Document Transmittal Form

PSEG NUCLEAR LLC
EOF IMPLEMENTING PROCEDURES

CHANGE PAGES FOR
REVISION #10

**PSEG NUCLEAR LLC EMERGENCY PLAN
EOF IMPLEMENTING PROCEDURES
TABLE OF CONTENTS
July 3, 2002**

FIGURE 2 - 1

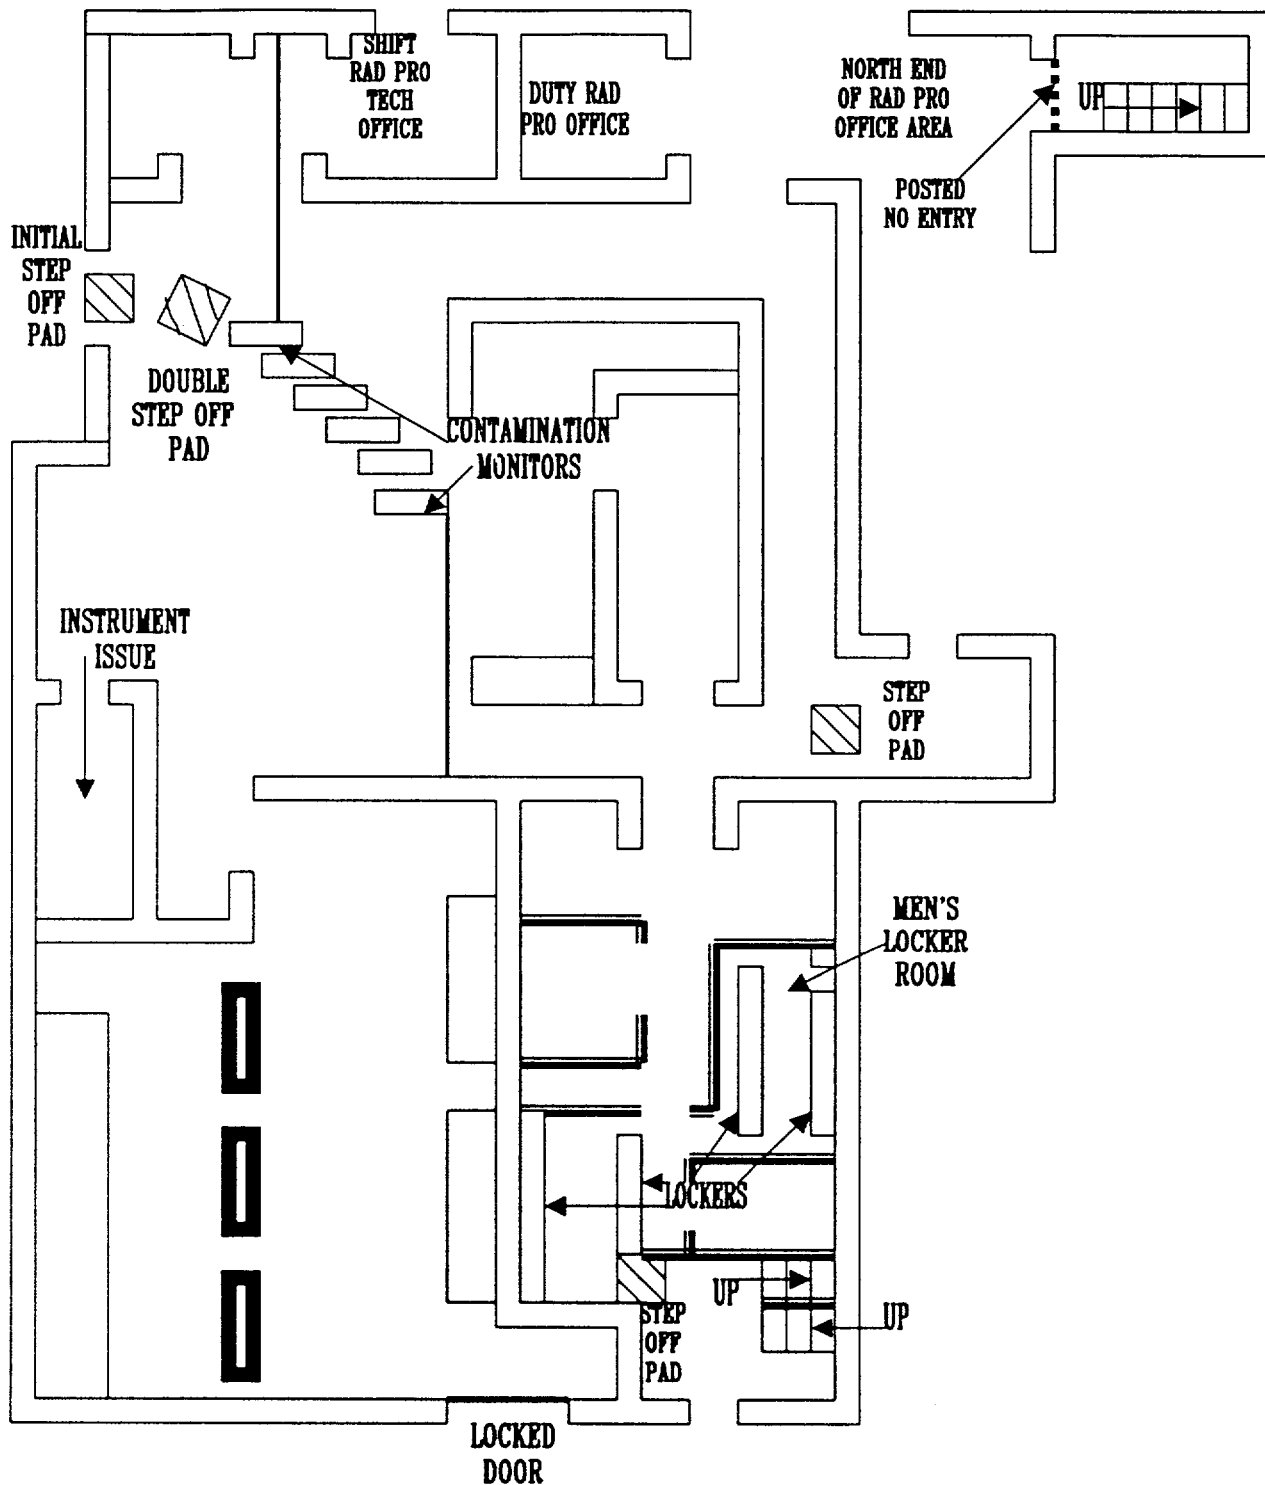
1. Added Step 3.1.5 concerning Assembly/Accountability to the Precautions/Limitations Section.
2. Revised Figure 2-1 to show a door should be posted no entry, instead of locking it. There is no locking mechanism in the door to allow the door to be locked.
3. Revised the title, Manger EP & IT to Emergency Preparedness Manager through out the procedure.
4. Contamination Control Guidance figures (1-1 through 1-4 & 2-1) were done and CAD and had to be added to the procedure. Redrew the figures, so they are now in the procedure.
5. This revision satisfies the requirement for a biennial review.

R-45 SKID (SAMPLING RIG)

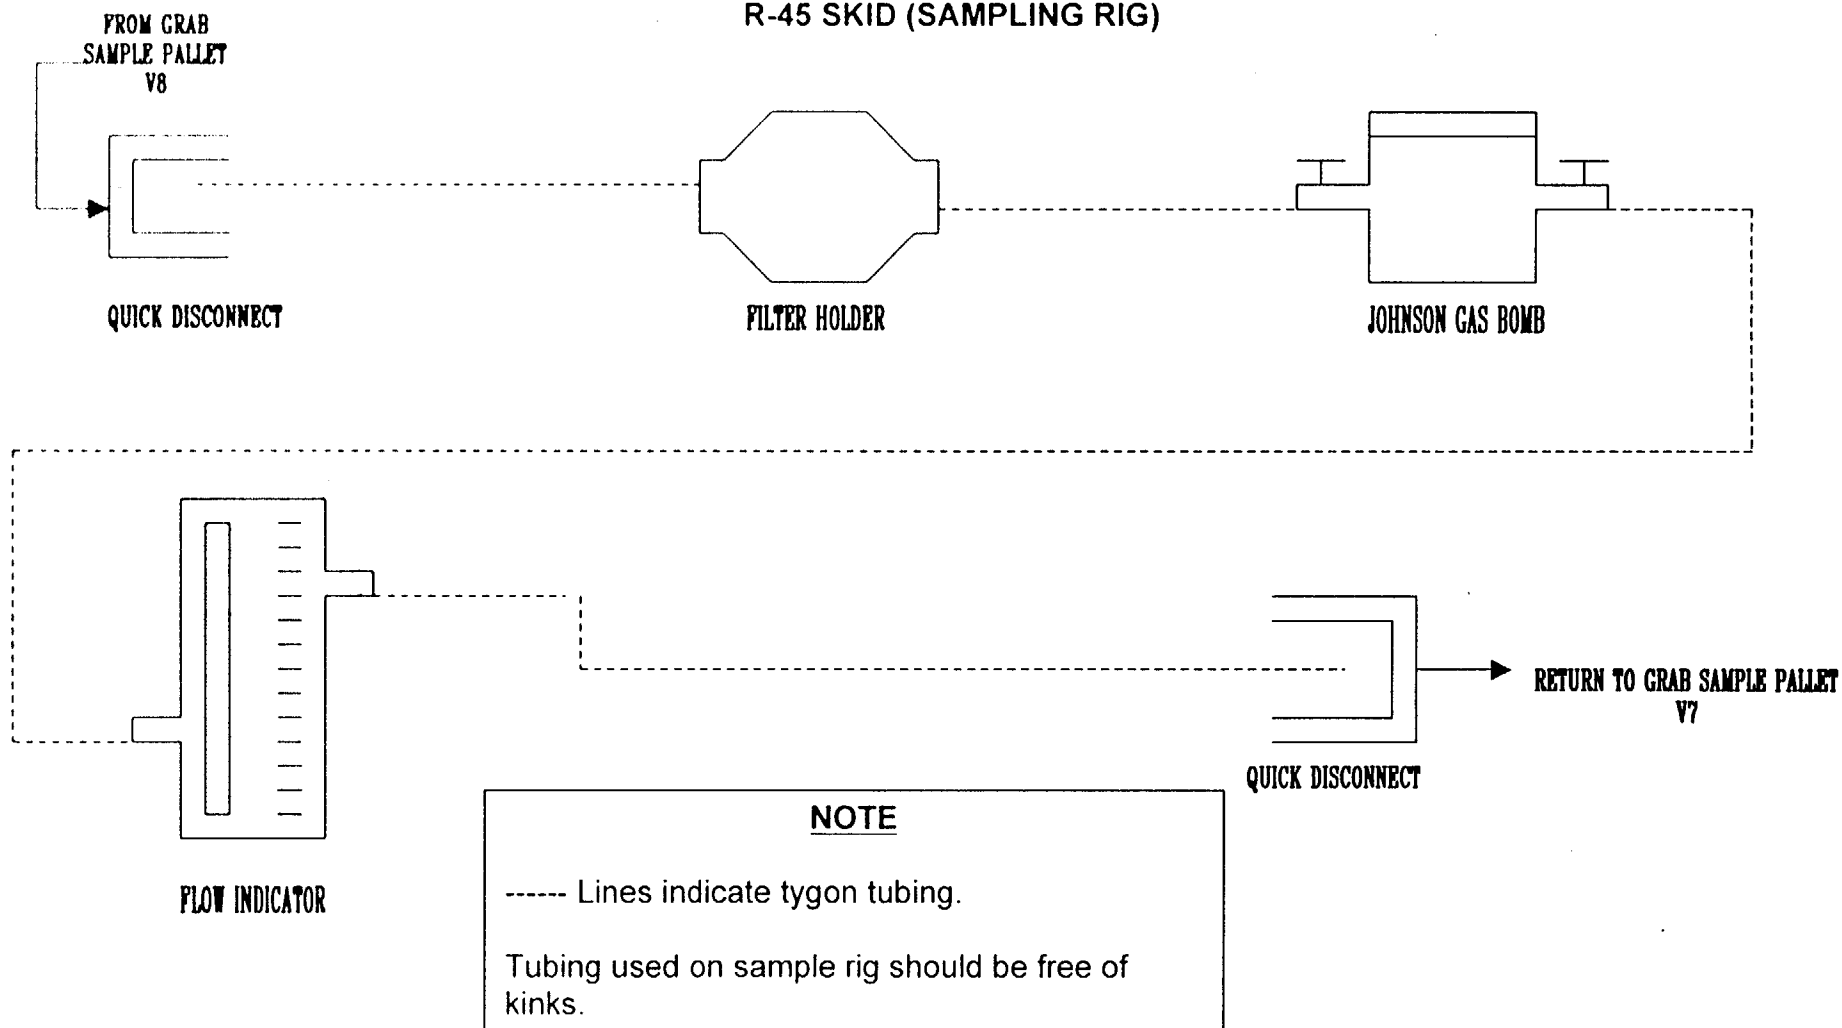
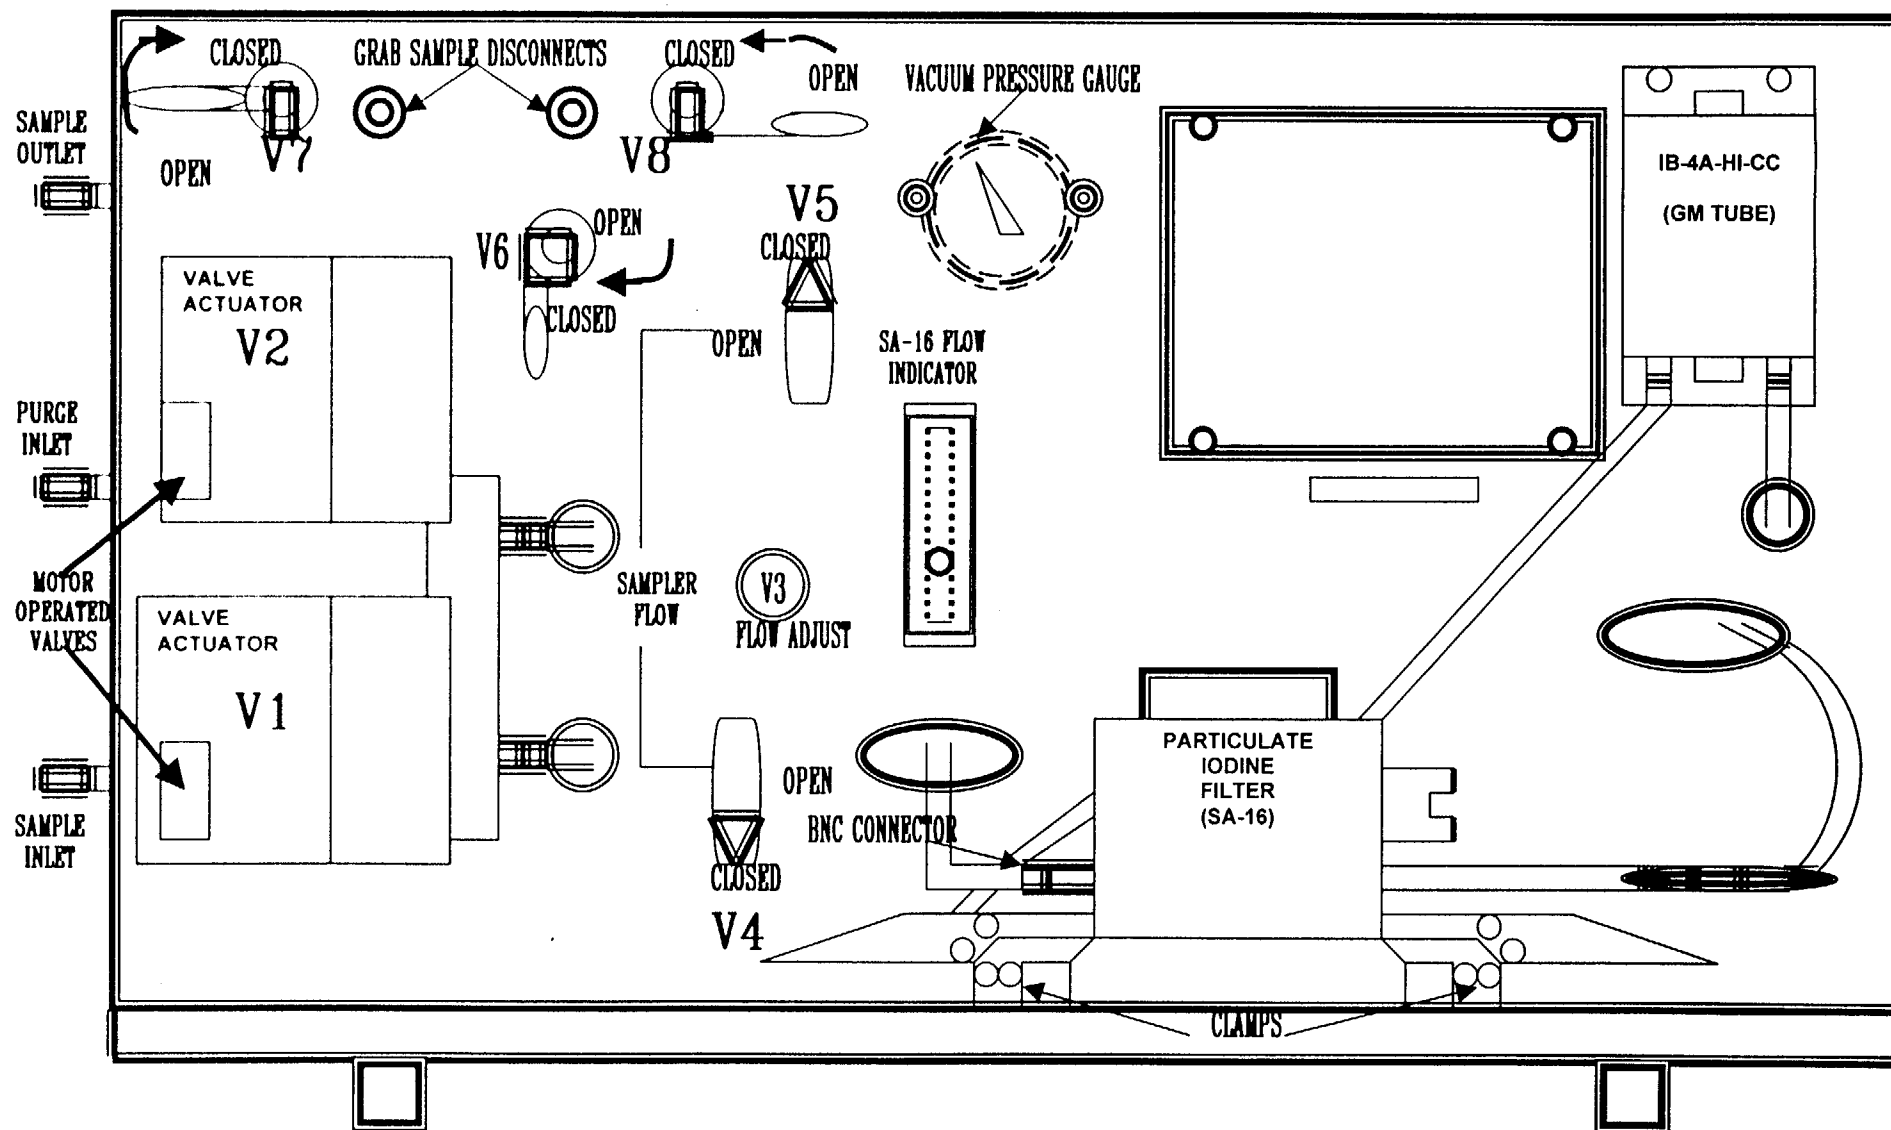
1. Revised the note prior to step 5.1 to clarify the priority and reason for performing the R45 grab sample and SA-16 sample.
2. Revised the order of the R45 Grab Sample and the SA-16 Sample sections to put the R45 Grab Sample section (5.1) first.
3. Enlarged the font and underlined 10 R/hr in the caution after step 5.2.32. Also rewrote one line for better clarity.
4. Attachments 1 and 2 were drawn by CAD and had to be added to the procedure. Redrew Attachments 1 and 2 in this revision of the procedure, so the drawings would be contained in the body of the procedure.
5. This revision satisfies the requirement for a biennial review.
